## **CNP UNITS 1 AND 2 IMPROVED TECHNICAL SPECIFICATIONS CONVERSION**

### **ITS CHAPTER 2.0 SAFETY LIMITS**

#### **Revision 0**

**Current Technical Specification (CTS) Markup  
and Discussion of Changes (DOCs)**

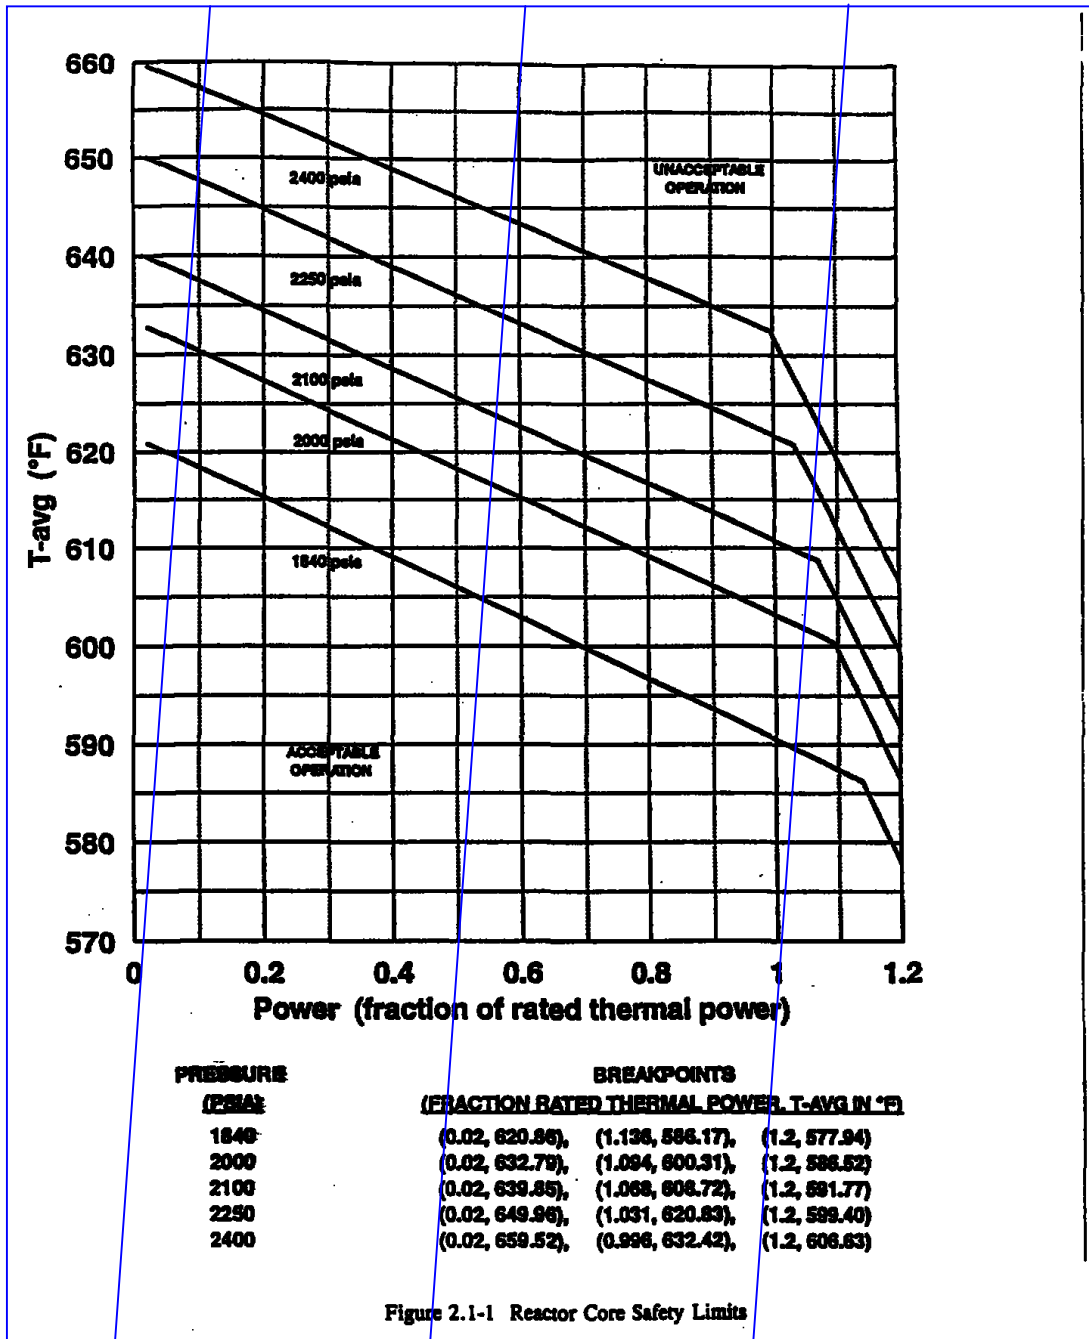
2.1.1 The combination of THERMAL POWER, pressurizer pressure, and the highest operating loop coolant average temperature ( $T_{avg}$ ) shall not exceed the limits shown in Figure 2.1-1 for 4 loop operation.

A.2

the COLR

Add proposed SL 2.1.1.1 and SL 2.1.1.2

LA.1

- A.2 CTS 2.1.1 references a curve providing limits on THERMAL POWER, pressurizer pressure, and the highest operating loop coolant average temperature (Tavg) "for 4 loop operation." ITS 2.1.1 does not contain this amplifying information.

This change is acceptable because the requirements have not changed. Both the ITS (ITS 3.4.4) and the CTS (CTS 3/4.4.1.1) require all four loops to be in operation in the applicable MODES (MODES 1 and 2). This change is designated as administrative because it eliminates redundant information in the CTS.

- LA.1 (*Type 5 – Removal of Cycle-Specific Parameter Limits from the Technical Specifications to the Core Operating Limits Report*) CTS 2.1.1 requires that the combination of THERMAL POWER, pressurizer pressure, and the highest operating loop coolant average temperature not exceed the limits in Figure 2.1-1.

ITS 2.1.1 states that the combination of THERMAL POWER, RCS highest loop average temperature, and pressurizer pressure shall not exceed the limits specified in the COLR and provides specific limits on DNBR and peak fuel centerline temperature. This changes the CTS by relocating limits that must be confirmed on a cycle specific basis to the COLR. The limiting Safety Limit parameters are retained in the SL.

The removal of these cycle specific parameter limits from the Technical Specifications to the COLR and the retention of the limiting Safety Limits in the Technical Specifications is acceptable because the cycle specific limits are developed or utilized under NRC-approved methodologies that ensure the Safety Limits are met. The NRC documented in Generic Letter 88-16, "Removal of Cycle-Specific Parameter Limits From Technical Specifications," that this type of information is not necessary to be included in the Technical Specifications to provide adequate protection of public health and safety. The ITS still retains the Safety Limits. NRC-approved Topical Report WCAP-14483-A, "Generic Methodology for Expanded Core Operating Limits Report," determined that the specific values for these parameters may be relocated to the COLR provided the limiting Safety Limits continue to appear in the Technical Specifications. The methodologies used to develop the parameters in the COLR were approved by the NRC in accordance with Generic Letter 88-16. Also, this change is acceptable because the removed information will be adequately controlled in the COLR under the requirements provided in ITS 5.6.5, "Core Operating Limits Report." ITS 5.6.5 ensures that the applicable limits of the safety analysis are met (e.g., fuel thermal mechanical limits, core thermal hydraulic limits, Emergency Core Cooling Systems limits, and nuclear limits such as SDM, transient analysis limits, and accident analysis limits). This change is designated as a less restrictive removal of detail change because information relating to cycle specific parameter limits is being removed from the Technical Specifications.

COOK NUCLEAR PLANT - UNIT 2

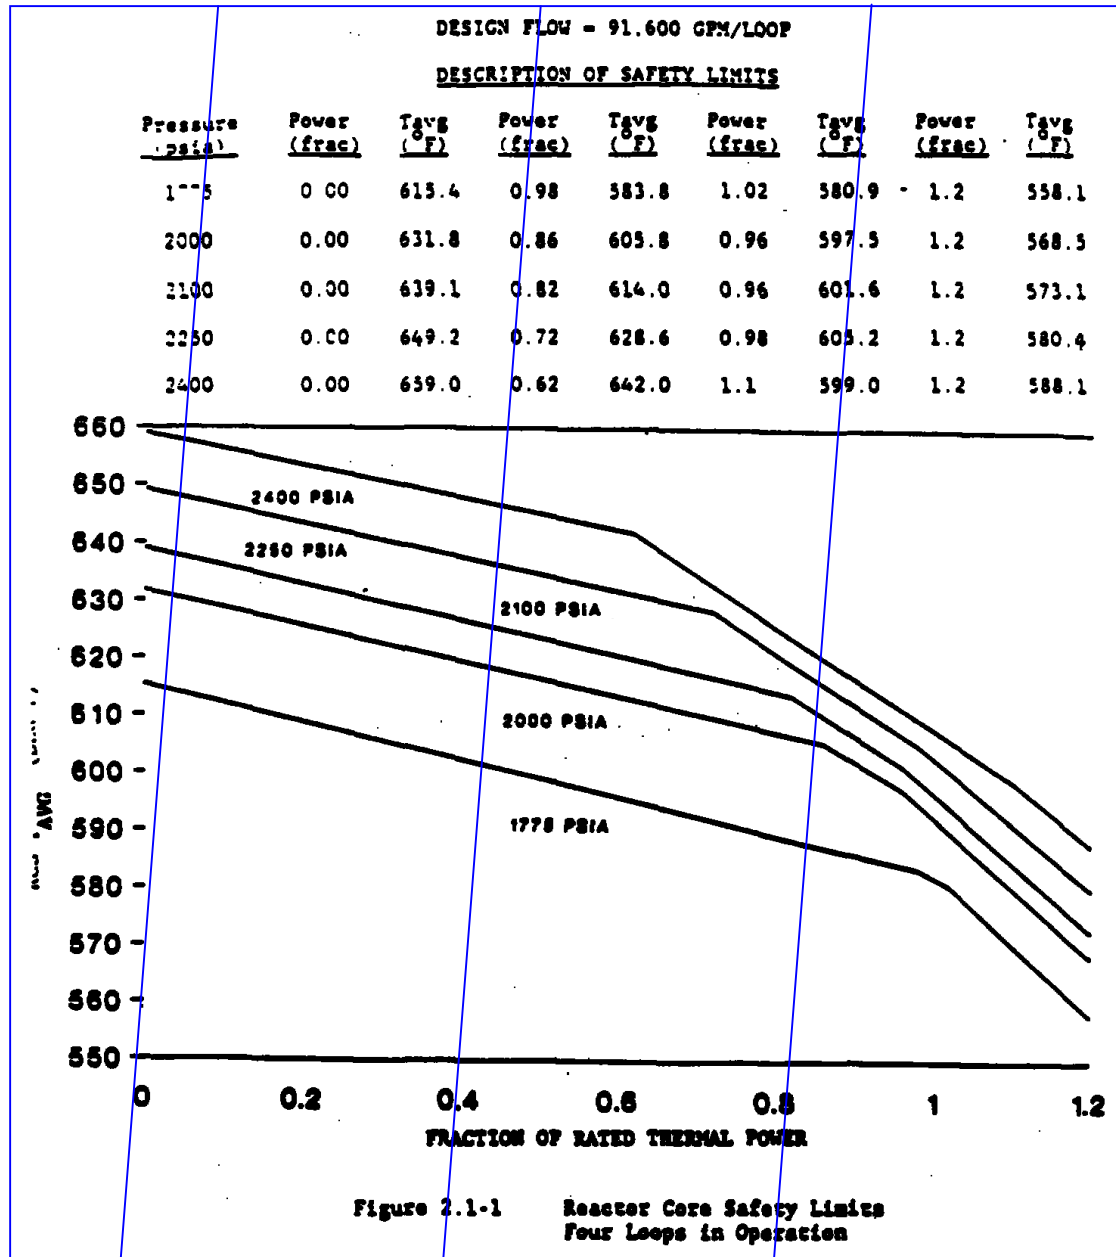
2.1.1 The combination of THERMAL POWER, pressurizer pressure, and the highest operating loop coolant average temperature ( $T_{avg}$ ) shall not exceed the limits shown in Figure 2.1-1 for 4 loop operation.

A.2

the COLR

Add proposed SL 2.1.1.1 and SL 2.1.1.2

LA.1
